ACMR EAST COAST OCEAN STRUCTURES
REVIEW OF SYSTEMS ANALYSIS PHASE

ACMR EAST COAST OCEAN STRUCTURES
REVIEW OF SYSTEMS ANALYSIS PHASE

Report No. 76-10-1

ACMR East Coast Ocean Structures
Review of Systems Analysis Phase

FIG. 3. FOUR PILE CONCEPT, CONCEPTUAL DESIGN CRITERIA

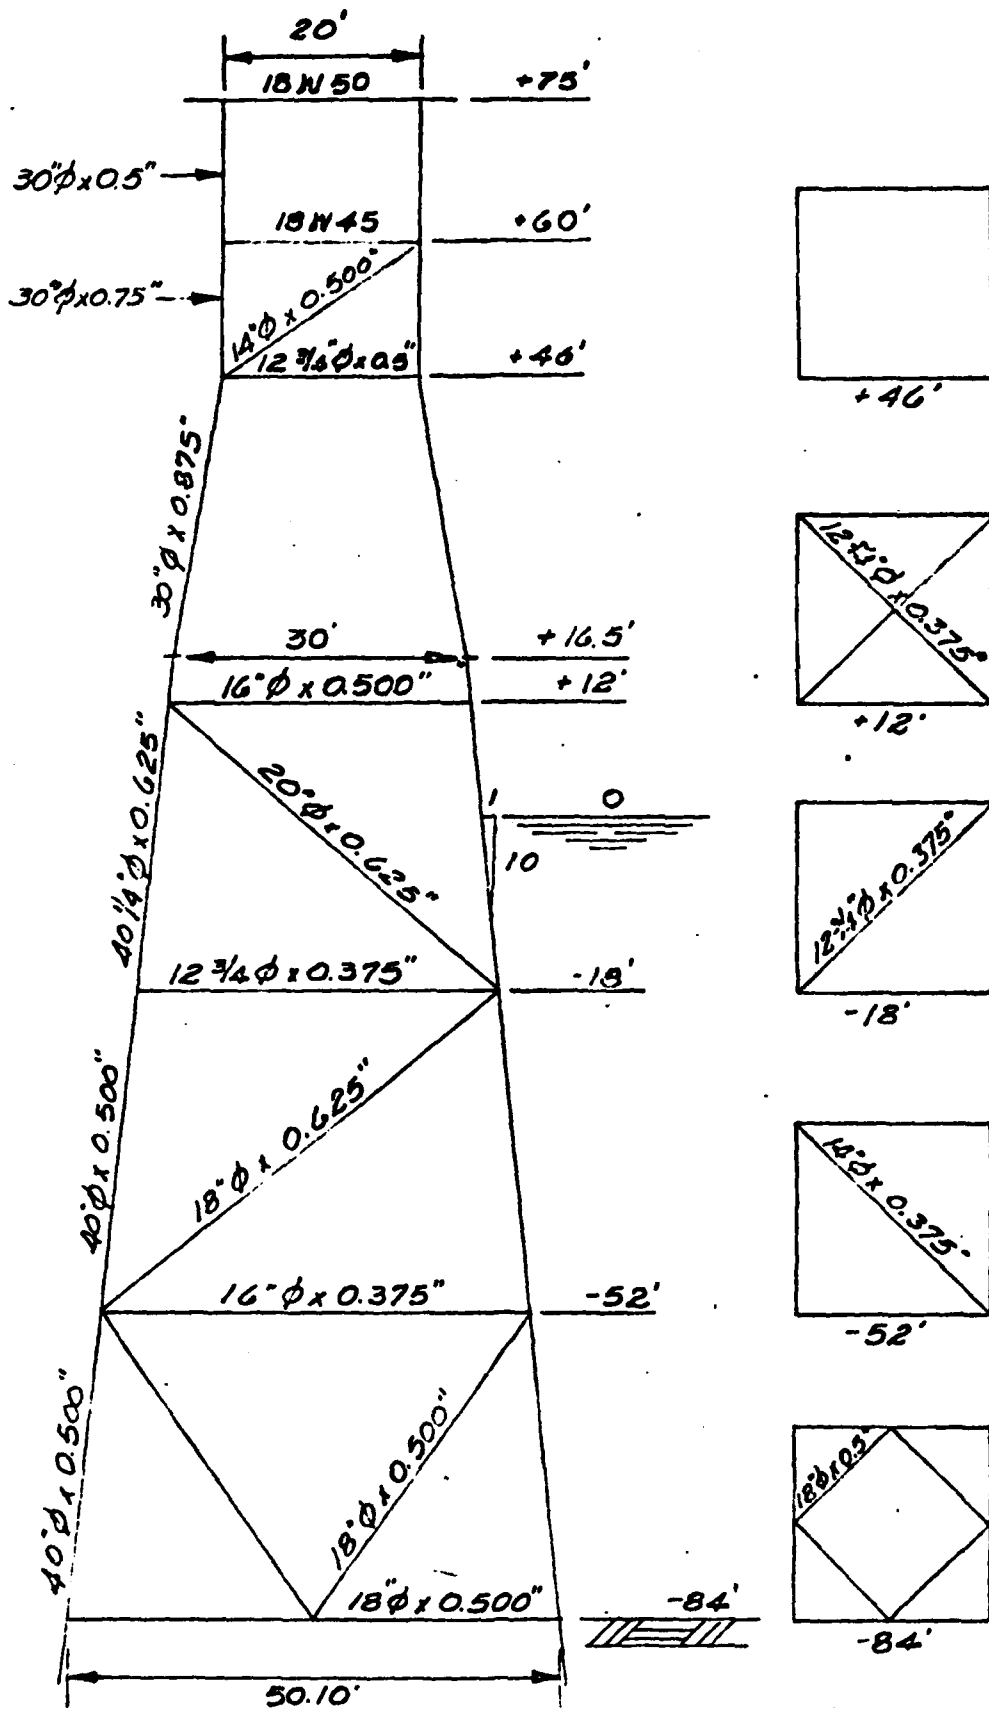
A comparison of Fig. 3 with the structural concept shown on page 12.07 of the A&E report⁷ indicates fairly close agreement in member sizes except for the superstructures which are substantially different in width and for the horizontal bracing which generally is controlled by the designer's choice of an allowable slenderness ratio rather than load carrying capacity. The jacket weight for the structure shown in Fig. 3 is about 276 kips which is 13% lower than the jacket weight reported by the A&E, mainly due to difference in horizontal bracing and possibly can sizes and corrosion allowances. The superstructure weight of 144 kips is considerably lower than the A&E's 172 kips (16%) due mainly to the different deck width. The A&E does not show a piling weight required for stresses only but it is noted that the piling shown is about 16% lighter than the 36 in. x 2 in. piling mentioned above which showed fairly good marginal drivability.

Revised member sizes are shown in Fig. 3, and required piling length and wall schedule are shown in Fig. 4.

FIG. 6. FOUR PILE CONCEPT, MAXIMUM ANTICIPATED CRITERIA

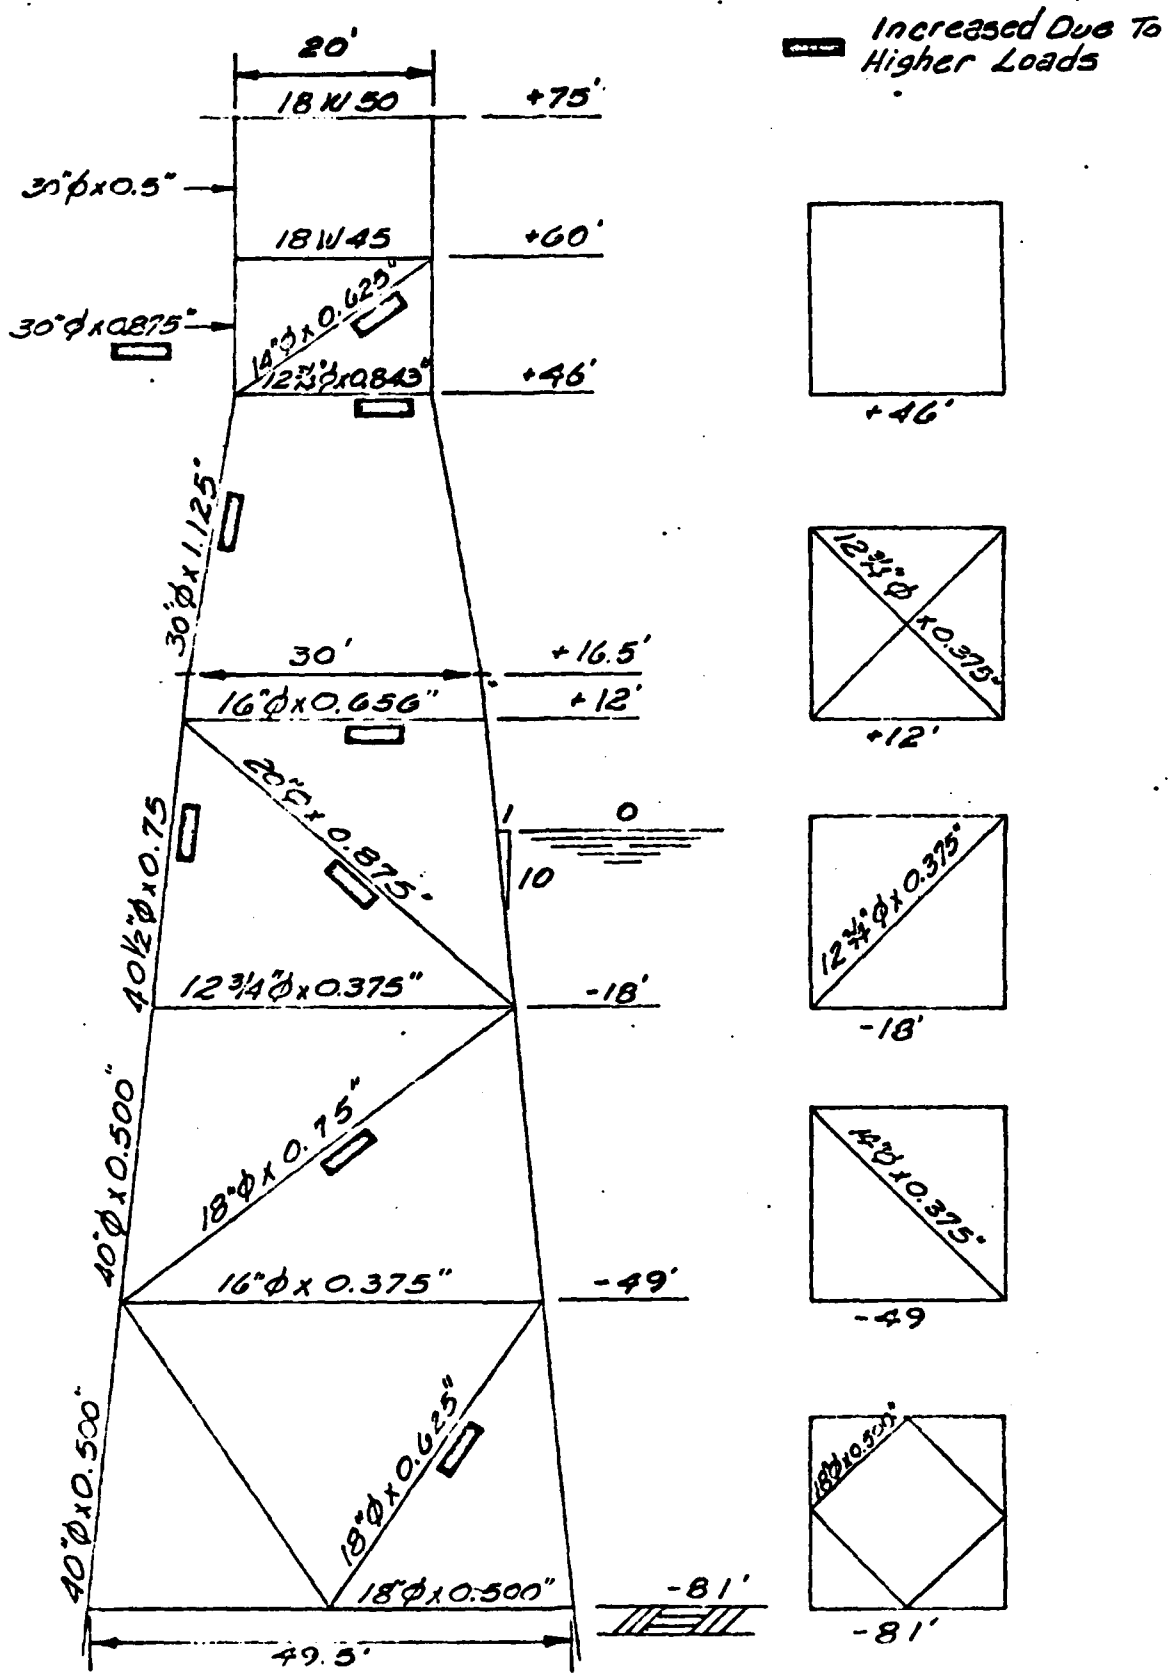
In order to predict the magnitude of the effect of the increased forces on structural weight, the structure in 81 ft MLW was analyzed using this maximum waveload case. Revisions were made to the member sizes, and the pile schedule, and are shown in Figs. 5 and 6. The net increase in wave forces from that based on the conceptual design criteria was 23%, with a 25% increase in moment. Increases in the weight of structural steel amount to about 26% with most of it in the piling (41%) as shown in Table 2. The piling weights shown in Table 2 do not reflect the additional steel that might be required for installation in the form of extra wall thickness for driving stiffness or insert piling.

Item	Structural Weight (Kips)		% Increase
	Conceptual Design Criteria	Maximum Anticipated Criteria	
Jacket	276 kips	315 kips	13
Superstructure	144 kips	159 kips	10
Piling* Rec'd for stress	366 kips	515 kips	41
TOTAL	786 kips	989 kips	26
